East Durham Wind, LP

Modification Report No. 1 – East Durham Wind Energy Centre

111-15446-00

August 28, 2014

Figure 3: Revised Access Road Entrance to Turbine 11

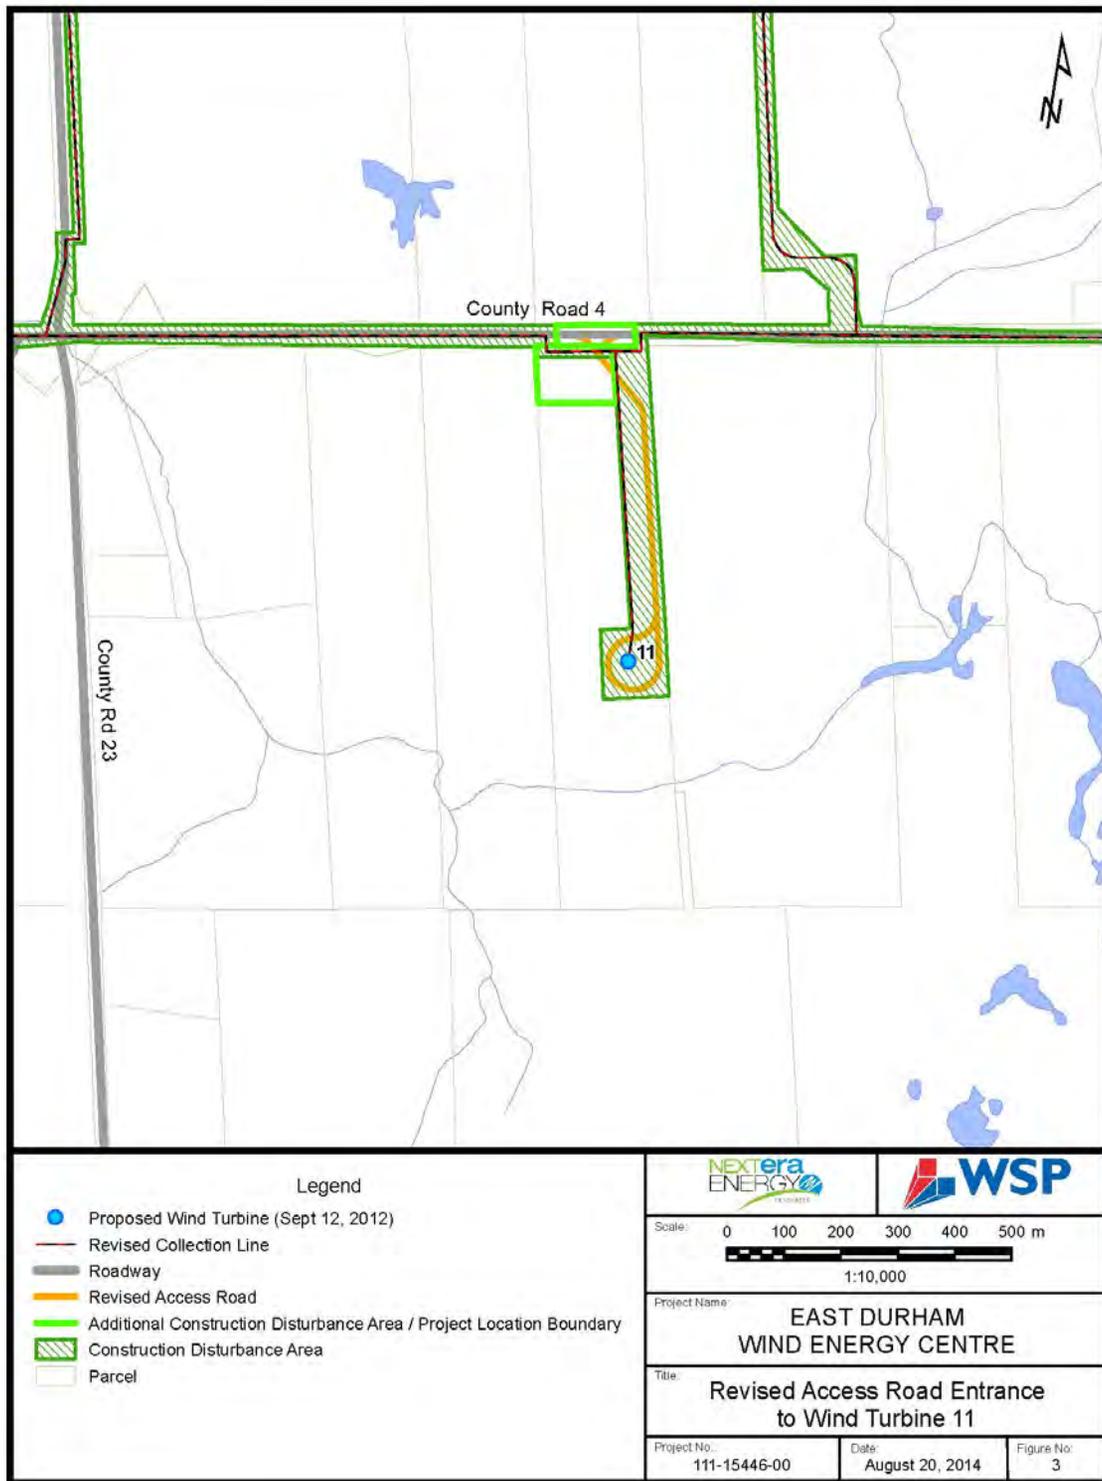
In order to comply with Grey County's revised entrance permit policy for entrances to access roads, the proponent has recognized that the access road to Turbine 11 may need to shift to the west slightly as it approaches County Road 4. As a result, the road right-of-way (ROW) directly adjacent to the property associated with Turbine 11, as well as additional land within the property parcel itself, are proposed for inclusion in the CDA for the Project. The area is currently under active agricultural use. A review of significant features (woodlands, wetlands or valleylands) located within 120m of the additional CDA indicates that a significant wetland (WE-12) is located 95m to the southwest and a significant woodland (WO-05) is located 20m to the east.

The portion of WE-12 that lies within 120m the additional CDA is a coniferous swamp that is part of the Beaver Meadow Provincially Significant Wetland (PSW). This PSW is a wetland complex made up of a number of wetland units to comprise the largest wetland feature identified in the project area. WE-12 has already been identified as being within 120m of the construction disturbance area of Turbine 11 that includes an access road and underground electrical collection in existing NHA documents for the Project. The distance of 95m from this feature identified as a result of the modification does not represent a greater impact than what was previously identified (47m); therefore no additional impacts or mitigation measures, beyond what is already identified in the Environmental Impact Study (EIS) in the NHA documents for the Project, are identified.

In the case of WO-05 the project layout (access road and underground electrical collection) presented in existing NHA documentation for the Project was already identified as being immediately adjacent (>0m) to the feature. The distance of 20m from WO-05 identified as a result of the additional CDA does not represent a greater impact than what was previously identified (>0m); therefore no additional impacts or mitigation, beyond what is already identified in the EIS for the Project, are identified.

As a result of the additional CDA, a small area of additional Generalized SWH of the same type identified in existing NHA documentation for the Project, was identified. No additional SWH was identified within 120m of the additional CDA.

Figure 4: Revised Access Road Entrance to Turbine 11 with Archaeological Buffers

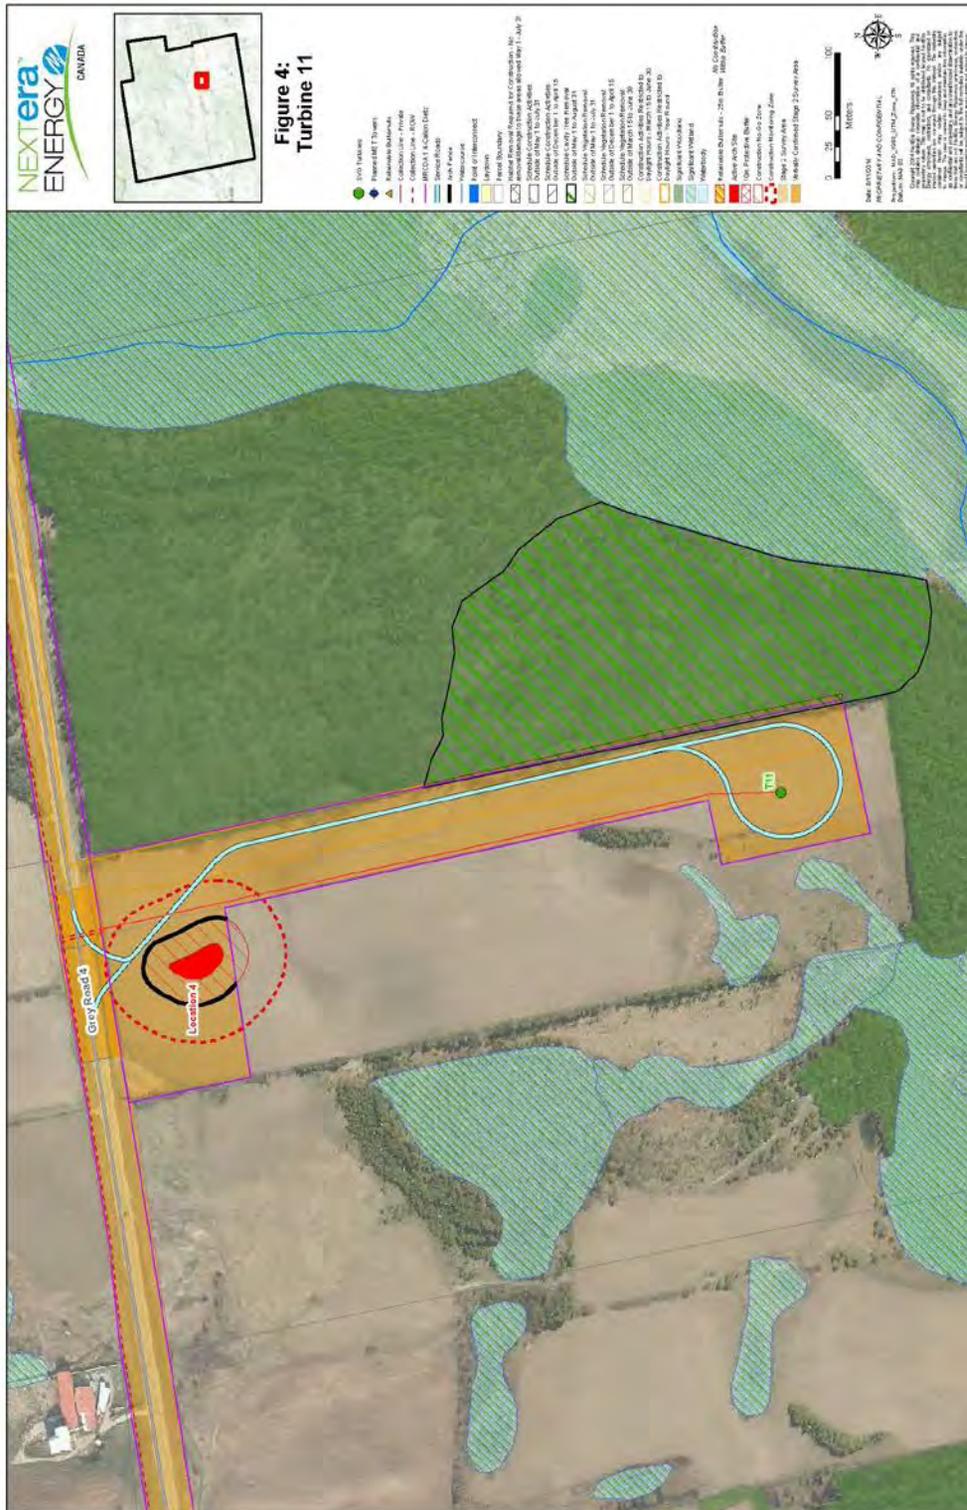
The three site access entrances which are proposed to be changed were subject to additional Stage 2 archaeological field work which was undertaken by URS in October 2013. The findings and all field work have been documented in the "Additional Stage 2 Archaeological Assessment East Durham Wind Energy Project Alternative Access to Turbines and other Infrastructure Geographic Township of Glenelg, now West Grey Township, Grey County, Ontario" (January 29, 2014). Following completion of the Stage 2 archaeological assessment it was found that no new archaeological material or sites were identified and no further archaeological assessment was required for either of the access road entrances or underground electrical collection line associated with Turbine 4 or Turbine 10. There is a new site (identified as Location 4 site) that is located in the revised entrance area for Turbine 11, which would require a Stage 3 archaeological assessment if the area is to be impacted. Both the road entrance and the underground electrical collection line associated with Turbine 11 are sited to avoid the archaeological site and the associated 20 m buffer. Based on this no Stage 3 archaeological assessment will be required however a Monitor will need to be present during construction for the area within 20 m to 50 m of the Location 4 archaeological site that will be impacted (refer to Figure 4 below which outlines Location 4 and the associated archaeological buffers).

Following completion of the additional Stage 2 archaeological assessment there were no new archaeological material or sites identified for Turbines 4 or 10 and there is a new site (identified as Location 4 site) that is located in the revised entrance area for Turbine 11 that can be avoided and thus no further archaeological assessment was required for expansion of the CDA to accommodate the three revised access road entrances (see Table 2-1), on the provision of a Monitor to be on-site during construction of the road entrances for Turbine 11 in the areas within 20 m to 50 m of the Location 4 archaeological site.

Figure 5: Revised Project Location

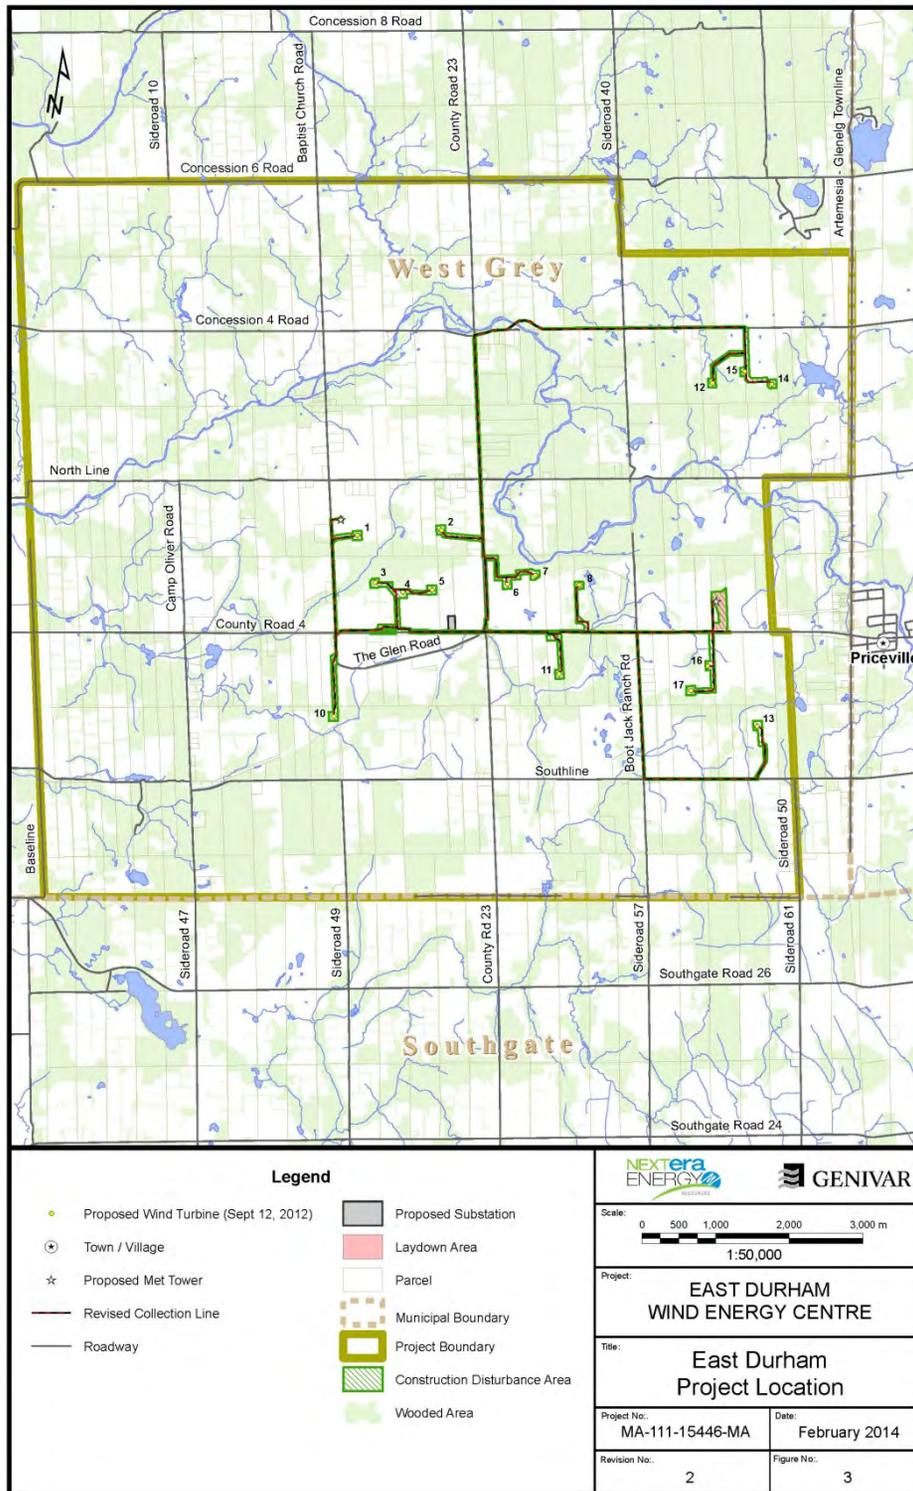
Figure 5 illustrates the modified Project Location.

Since submission of the REA application to the MOE, the proponent has identified the need to expand the Project Location due to an increase in the Construction Disturbance Areas (CDA) associated with the installation of three new access road entrances and associated underground electrical collection lines. These modifications to the location of three access road entrances are needed to accommodate Grey County and the Municipality of West Grey entrance permit requirements.

Figures 1, 2 and 3 show the existing construction disturbance areas (CDA) and the proposed additional CDA to accommodate the three new access road entrances and the associated underground electrical collection line. The original proposed CDA combined with the additional CDA represent the modification to the Project Location to accommodate the three revised access road entrances. While the figures in this modification report show a proposed access road and collection line, there is flexibility as the siting of the collection line and access roads can be anywhere within the full CDA (original and additional areas).
